WTC DRAWING
BOOK 19
AB-1–K-1055

PROJECT: THE WORLD TRADE CENTER | TITLE: DRAWING BOOK 19 - REVISIONS AFTER FABRICATION | DATE: 5/18/73

SKILLING - HELLE - CHRISTIANSEN - ROBERTSON	Structural & Civil Engineers	
PROJECT: THE WORLD TRADE CENTER	TITLE: DRAWING BOOK 19 - REVISIONS AFTER FABRICATION - GENERAL NOTES	DATE: 8/15/68

REVISIONS
1-15-72 Gen. Rev.
6-30-72
8-31-72

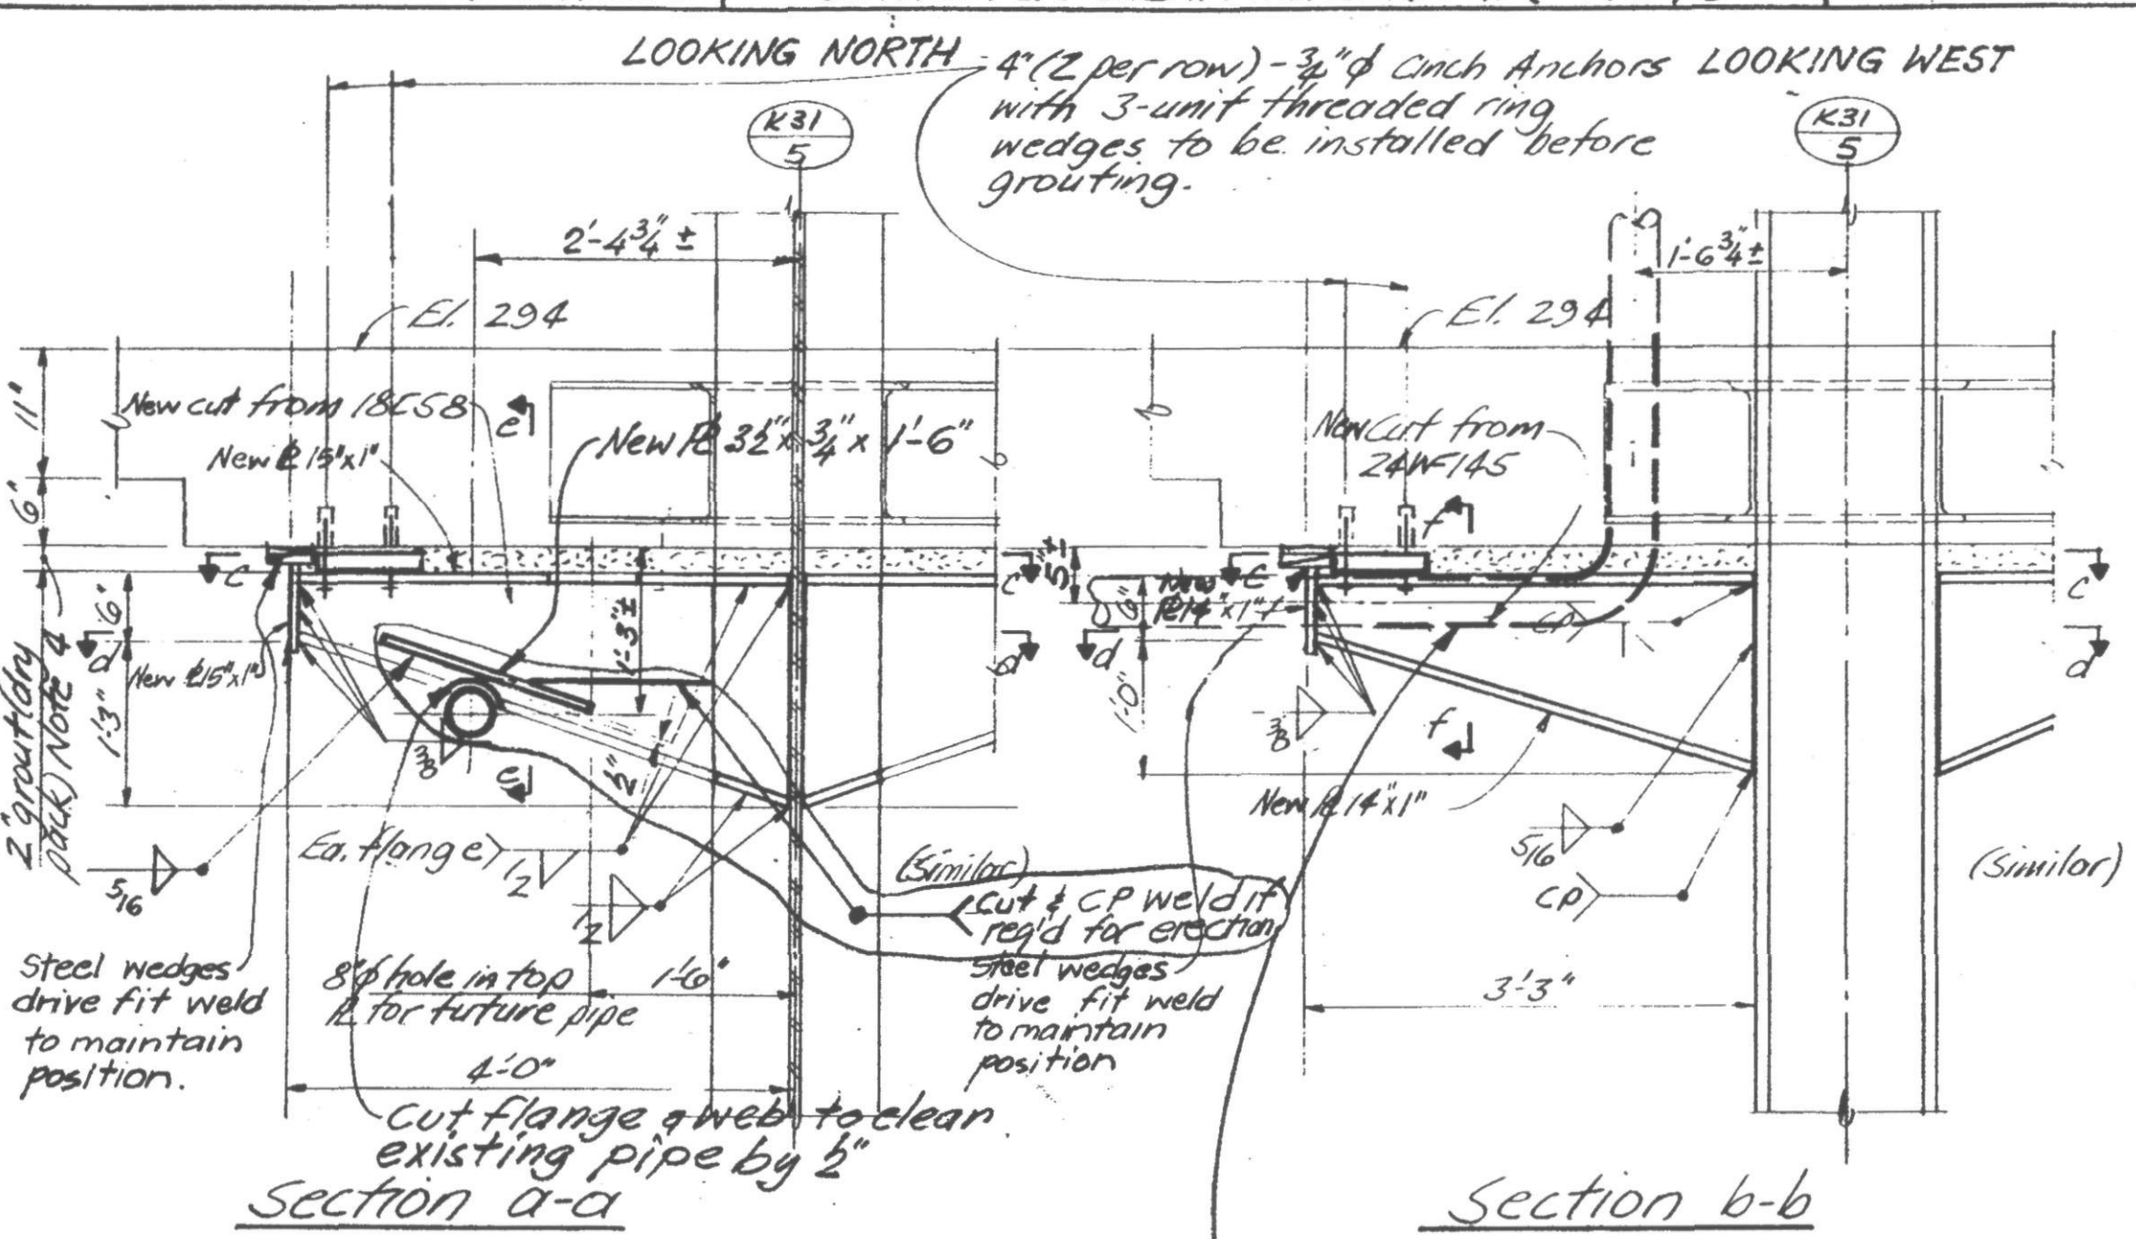
Remove existing pipe to clear new shear head. Pipe located in different position will be shown in future Central Service Drawings
